REGIONAL REVIEW NOTIFICATION

ARC REVIEW CODE: R2112031

Name of Proposal: Project Revive DRI 3489

Description: A Development of Regional Impact (DRI) review of a proposal to build a warehouse/distribution complex on approximately 159 acres in the City of Atlanta. The site is on the west side of Marietta Road NW, on the former site of the CSX Tilford railyard. Most of the site is currently covered with gravel; several mapped and unmapped streams traverse the site. The development plan totals 1,466,220 sq. ft. and includes multiple warehouse/distribution buildings (totaling 1,245,537 sq. ft.) and an e-commerce last-mile distribution facility (at 220,683 sq. ft.); a total of 1,739 parking spaces are proposed.. Site access is proposed via an existing driveway on Marietta Road about one mile southeast of Bolton Road (cars only); a driveway on Marietta Road opposite Annie Street and Laurel Avenue (cars and delivery vans only); and a realigned and rebuilt extension of the private road Thomas Street, connecting the site directly to Marietta Boulevard to the east (truck entrance/exit). The local DRI trigger action is a parking variance application. The expected buildout year is 2023.

Stream Buffers

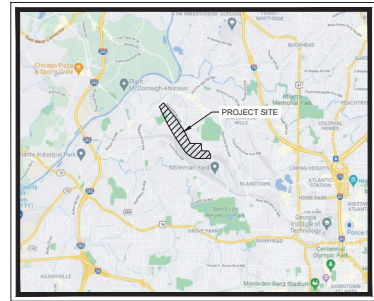
The USGS coverage for the project area shows one blue-line stream on or near the project property. The unnamed stream is shown on either side of the proposed project property near the intersection of Marietta Road and LaDawn Lane in the northwestern portion of the property. It appears that the stream is currently piped under the existing tracks and resurfaces to the southwest of the project property. The submitted site plan shows the short stretch of this stream between Marietta Road and the current piping with both the 25-foot State Sediment and Erosion Control buffer and the City 75-foot stream buffer. A tributary to the unnamed stream is also shown on the plans between the proposed project and Marietta Road. Both buffers are also shown on this stream. No new intrusions are shown on either stream. The site plan also shows two other short unmapped streams. The first parallels Marietta Road roughly between Ford Street and Westside Boulevard. The second stream starts between William Place and DuPont Avenue and runs south into the property and appears to be piped under the existing development. The 25-foot State Sediment and Erosion Control buffer and the City 75-foot stream buffer are shown on both streams. However, proposed construction, including an access road is shown on the first of these streams and apparent parking or storage areas is shown in the buffers of both streams. These intrusions may require variances under the both the City Stream Buffer Ordinance and the State 25-foot State Erosion and Sedimentation Control buffer. Any other unmapped streams on the property may also be subject to the City buffer ordinance. Any unmapped State waters identified on the property may also be subject to the State 25-foot Sediment and Erosion Control buffer.

Drawing name: K:\AMT_Marketing\TPA_Group\Tilford_Yards_Ph1\2Site_Planning\CAD\Plan\Sheet\C2-00_DRI_Site_Plan.dwg C2-00 DRI SITE PLAN - PHASE 1 Nov 23, 2021 4:08pm by: Heather Dolbach

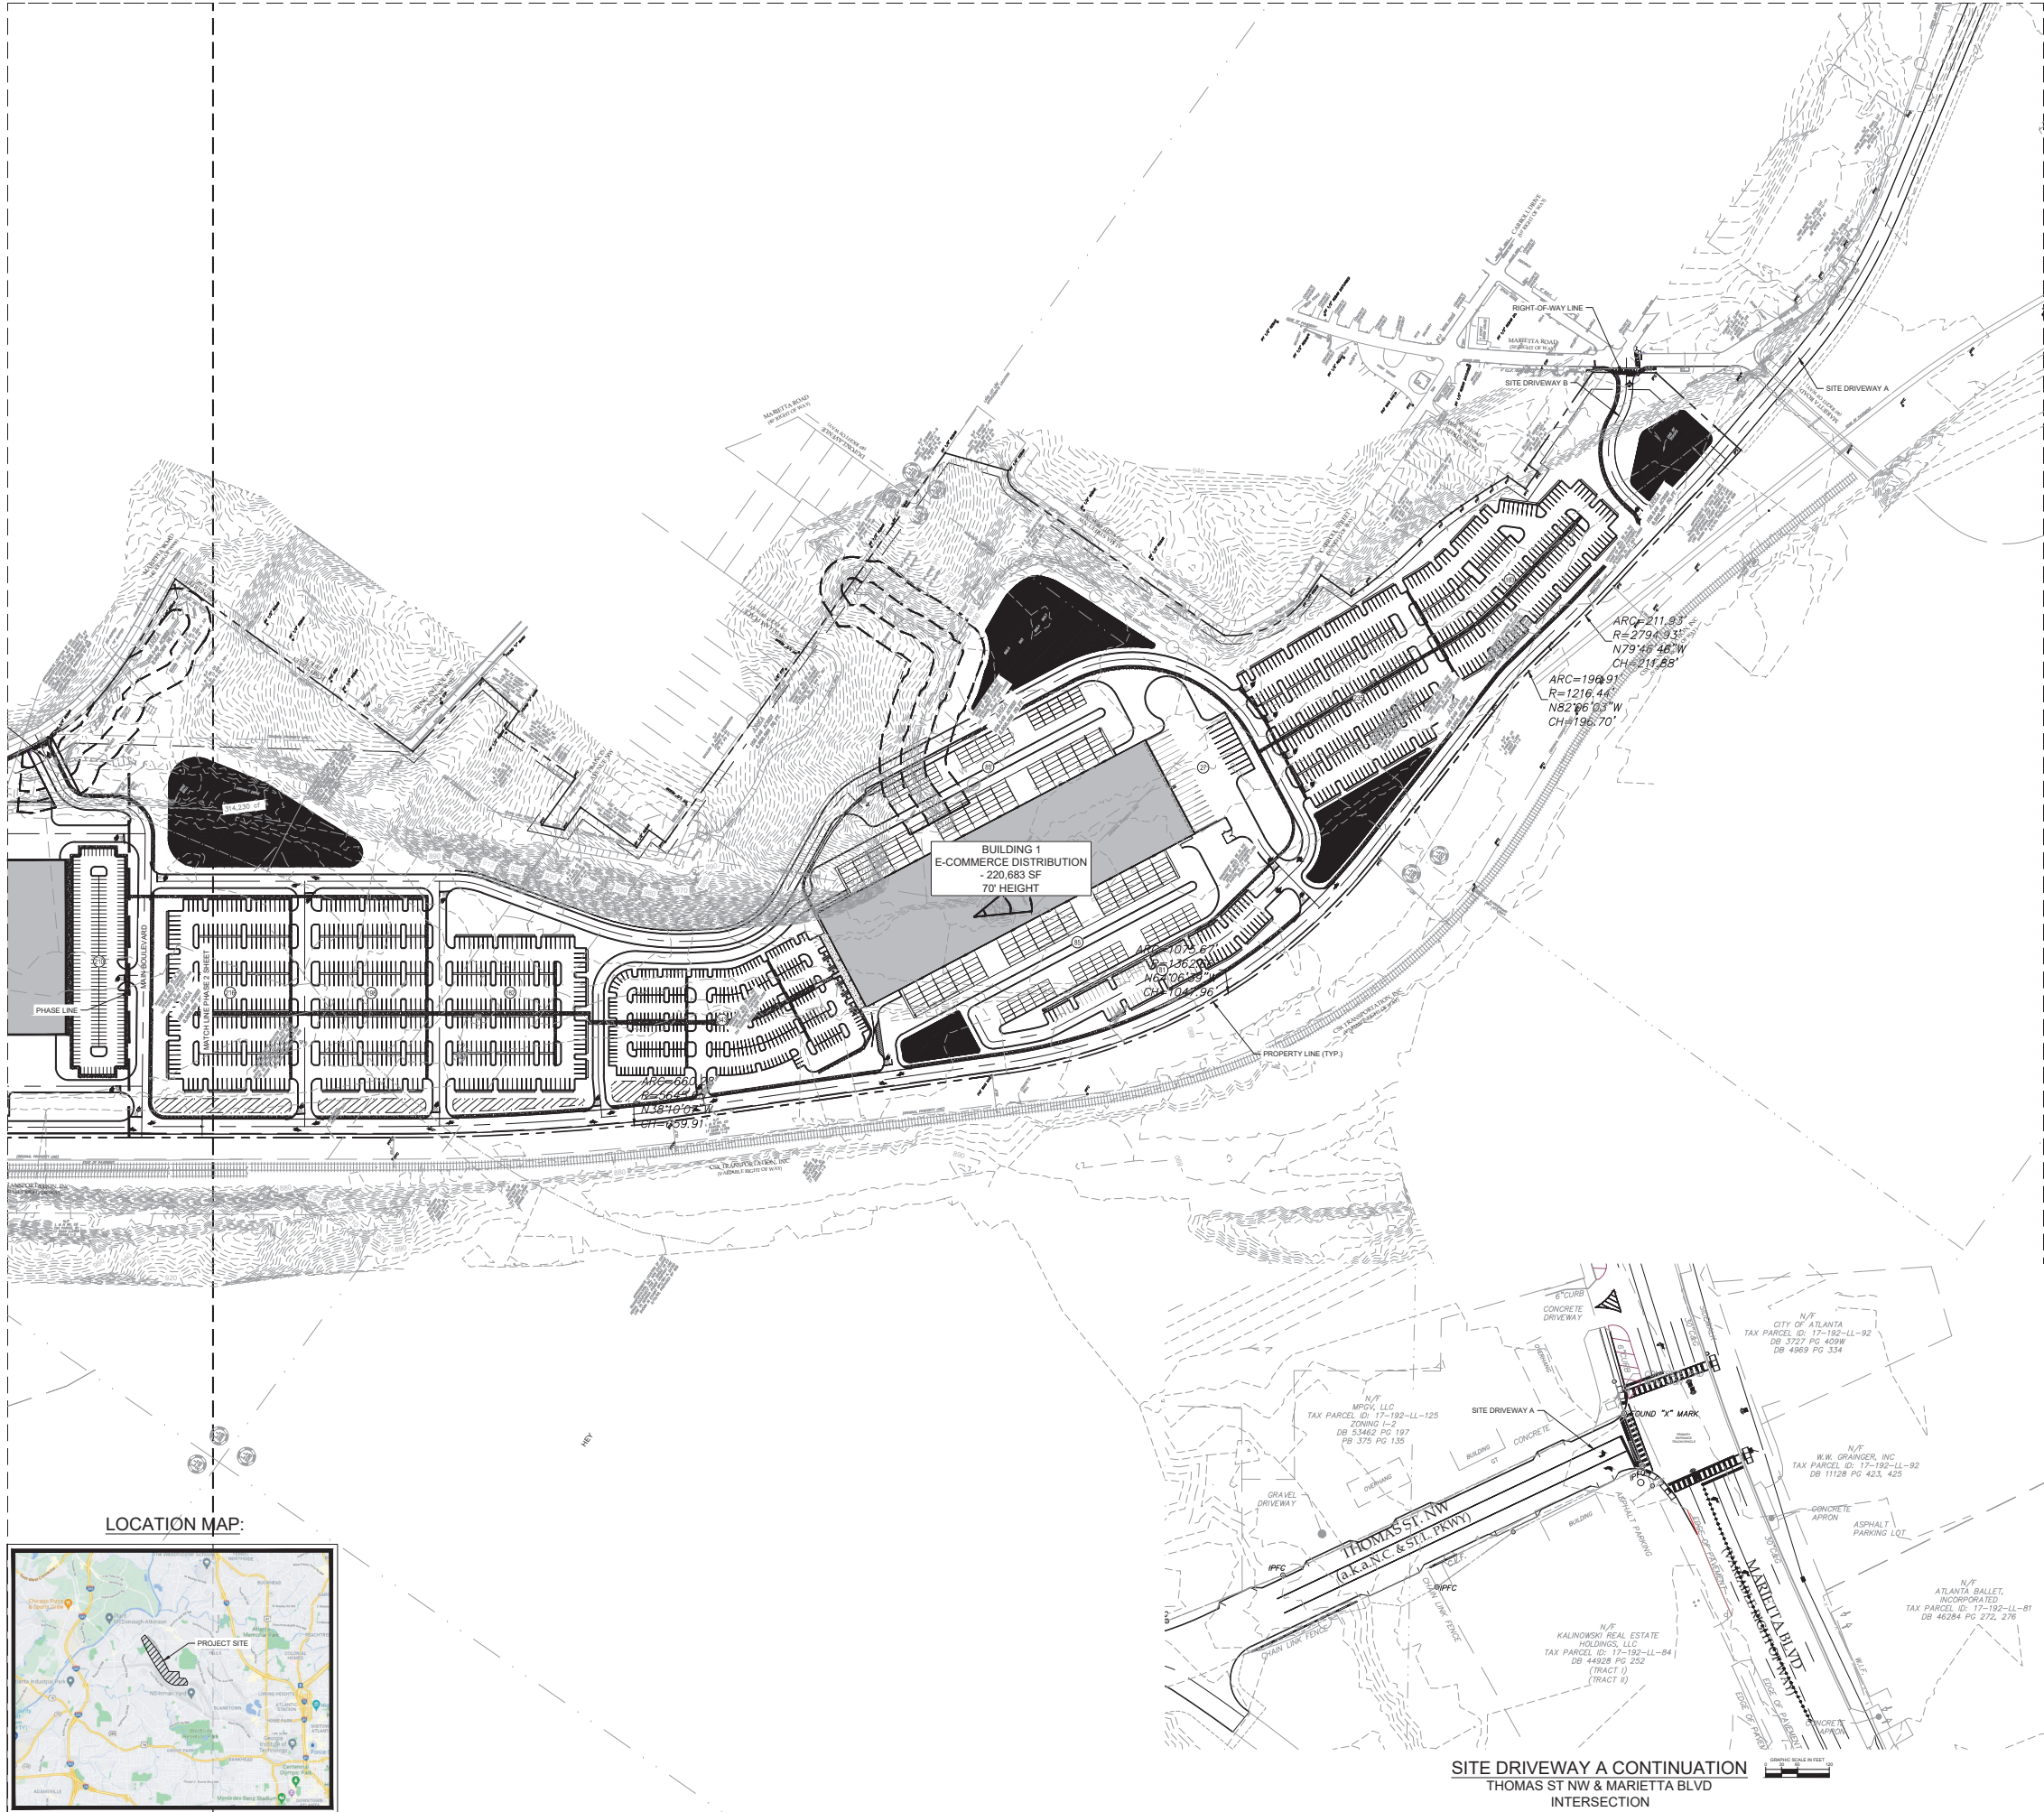
USGS data for the site shows one blue-line stream on either side of the proposed project property near the intersection of Marietta Road and La Dawn Lane in the northwestern portion of the property. It appears that the stream is currently piped under the existing tracks and resurfaces to the southwest of the project property. A tributary to the unnamed stream is also shown on the plans between the proposed project and Marietta Road. No new intrusions are shown within the buffer areas of either stream.

The site plan also shows two other short unmapped streams on the property. The first parallels Marietta Road roughly between Ford Street and Westside Boulevard. The second stream starts between William Place and DuPont Avenue and runs south into the property and appears to be piped under the existing development. However, proposed construction, including an access road is shown over the first of these streams and apparent parking or storage areas are shown within the buffer areas of both streams.

Generally development should avoid intrusion into stream buffers unless there are exceptional circumstances. Any intrusions may require variances under the both the City Stream Buffer Ordinance and the State 25-foot State Erosion and Sedimentation Control buffer. Any other unmapped streams on the property may also be subject to the City and State buffer areas.

The project proposes to construct approximately 1,739 parking spaces mostly in the form of surface parking. This is a very large increase in impervious area from the existing semi-pervious gravel areas used for railroad operations. This introduction of these very large areas of asphalt surface will generate substantial new runoff and contribute to the urban heat island effect experienced by the city of Atlanta. These extensive new surface parking lots should be designed to include green infrastructure to the maximum extent possible to limit runoff and achieve groundwater recharge. Further, the tree planting plan for the parking lot should ensure the greatest canopy coverage possible to mitigate the heat island impact of the very large asphalt area being added. The project can further support The Atlanta Region's Plan in general by incorporating other aspects of regional policy, including green infrastructure and/or low-impact design, e.g., pervious pavers, rain gardens, vegetated swales, etc., in parking areas and site driveways, and as part of any improvements to site frontages.
